NABCO ENTRANCES TECHNICAL BULLETIN

Grounding of the 1175

Bulletin Number: **7**

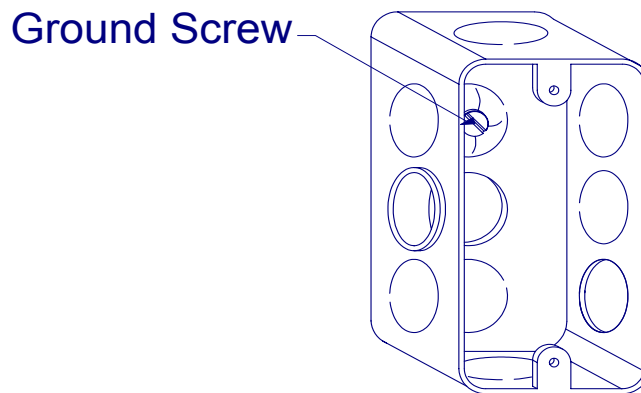
In order to provide a more sufficient method of grounding the 1175, a ground screw has been installed in the bottom of the switch junction box. This screw should be used for utility power grounding instead of header bolts specified in Section W, Step 2 of the Installation Manual.

Future printings of the
installation manual will reflect this correction.
